**CHANGE
ORDER**

PROJECT:	Washoe County – Nevada Shared Radio System	CHANGE ORDER NO.:	8
		DATE:	09/22/2020
SELLER:	Harris Corporation Communication Systems Segment	CONTRACT DATE:	September 27, 2018
SELLER ADDRESS:	221 Jefferson Ridge Parkway Lynchburg, VA 24501

Change Order No. 8 Detailed Description

Exhibit A, Exhibit 1: Statement of Work, System Description, pages 32-35**Microwave System**

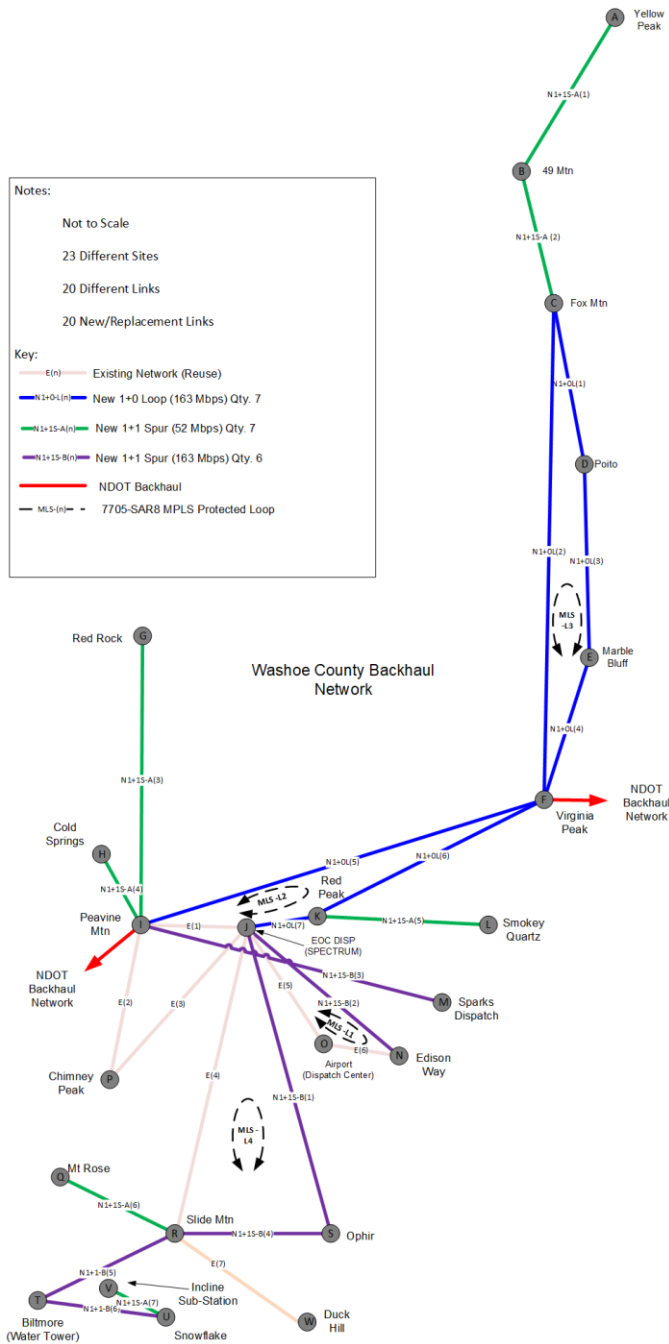
Harris will design and implement the new Washoe County microwave network that will provide high-speed wireless Ethernet transmission via the Nokia 7705 SAR-8 MPLS router installed at each Washoe County site. The new Washoe County microwave network will interconnect with the NDOT microwave network to form the NSRS backhaul. Harris will perform all services to implement all new equipment that includes microwave dishes, waveguide, radios, dehydrators, Network Management System and MPLS routers to provide network connectivity between the RF sites, cores, and existing PSAPs in Washoe County. Harris has reviewed the existing Comsearch Microwave Path Data Sheet provided by Washoe County and have used this data along with the selected RF sites in Washoe County to provide a microwave backhaul network solution that will interconnect to the NDOT microwave network which forms the NSRS. The new Washoe County microwave network solution comprises of 20 links which is a combination of loop-protected microwave links and monitor hot standby (MHSB) links. These links will interconnect the cores, RF sites and PSAPs to the NSRS. Each link will be designed with a path availability of 99.999% based on the receive threshold to provide the required link bandwidth.

The new Washoe County microwave network will include the Nokia 7705 SAR-8 MPLS routers for routing all packets between microwave sites, core locations and between NDOT and Washoe County microwave networks. In the event of a microwave path failure within a microwave loop, the 7705 SAR-8 will automatically reroute traffic to the opposite direction of the network. For RF sites that are connected by microwave spurs, a 1+1 MHSB radio will be installed to increase the reliability of the link. Harris has designed the microwave network based on the topology provided in Figure 23 below. The main microwave loop for interconnecting the two core sites in Washoe County consists of a 163 Mbps 1+1MHSB link with 7705 SAR08 MPLS backup loop protection using available bandwidth of existing links. The two cores are located at the EOC Dispatch and Edison Way locations. The northern loop and all spur sites will have links that support 52 Mbps radios. The Washoe County microwave network will interconnect with the NDOT microwave solution which share network nodes at Peavine Mtn and Virginia Peak site locations. Harris will coordinate with NDOT to support the routing of packets between the cores, RF sites and PSAPs located on the Washoe County side and the NDOT side of the NSRS.

The existing microwave links in Washoe County were considered and are based mainly on Nokia (formerly Alcatel) DS1 microwave circuits. Analysis of the existing microwave paths that will be reused are limited in bandwidth due to the nature of the existing DS1 signaling and will need to be replaced with all new Ethernet based radios to meet the NSRS bandwidth requirements. The existing DS1 links will remain operational until full cutover to the new NSRS. At that point, the equipment for ten existing links that are being replaced will be removed only.

- **Microwave System:** Harris will provide a new 20 link microwave solution that interconnects 20 site locations consisting of the core sites, RF sites and the existing PSAP locations within Washoe County. Harris will implement the Nokia 7705 SAR-8 MPLS router at each microwave site for the routing of packets throughout the new microwave network and will setup the routers to interface with the NDOT microwave network. Harris will coordinate with NDOT to configure the 7705 SAR-8 to properly route packets between NDOT and Washoe County microwave networks.
